Project IEEE 802.16 Broadband Wireless Access Working Group http://ieee802.or			
Fast Uplink Bandwidth Allocation for Intermittent Short Packets			
Date Submitted	2005-01-20		
Source(s)	Yerang Hur, Bong Ho Kim, Jungnam Yun, Jaehyeong Kim, Seyoung KimVoice: 408-986-1140 Fax: 408-986-1145 		
Re:	Corrigendum to IEEE Std 802.16-2004		
Abstract	Intermittent short packets cause network delays if bandwidths are allocated with contention-based CDMA bandwidth requests mechanism for OFDMA. This contribution proposes a contention-based bandwidth request mechanism for fast uplink bandwidth allocation so that OFDMA system can deliver intermittent short packets fast.		
Purpose	Review and adoption of the proposed text change into Corrigendum to IEEE Std 802.16-2004		
Notice	This document has been prepared to assist IEEE 802.16. It is offered as a basis for discussion and is not binding on the contributing individual(s) or organization(s). The material in this document is subject to change in form and content after further study. The contributor(s) reserve(s) the right to add, amend or withdraw material contained herein.

Fast Uplink Bandwidth Allocation for Intermittent Short Packets

Figure 1: Contention-based OFDMA BW Allocation Mechanism

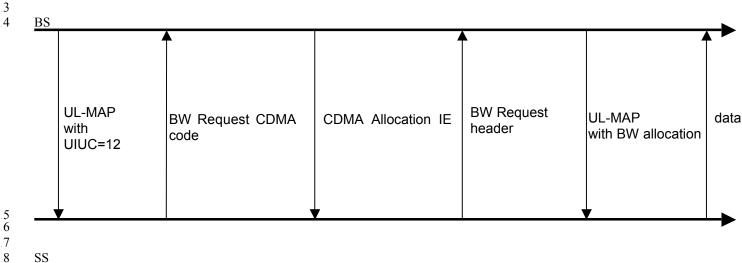
For delivering the intermittent short packets, an SS needs to request uplink bandwidth using contentionbased OFDMA BW requests described in 6.3.6.5. Figure 1 shows the contention-based OFDMA BW
allocation mechanism described in 6.3.6.5. It requires minimum five message transfers between BS and SS:
three from BS and two from SS until the SS starts to send data. This overhead can be reduced to three
messages: two from BS and one from SS, if the SS informs a BS that data to be transmitted are short.

1. A SS sends a bandwidth request using the Fast BW Request CDMA code, if the amount of the packets is less than *m* bytes, where *m* is implementation specific.

2. If the Fast BW Request code is identified successfully, the BS sends Fast_BW_Allocation_IE to the SS with
 duration allocated.

3. The SS transmits data over the bandwidth allocated.
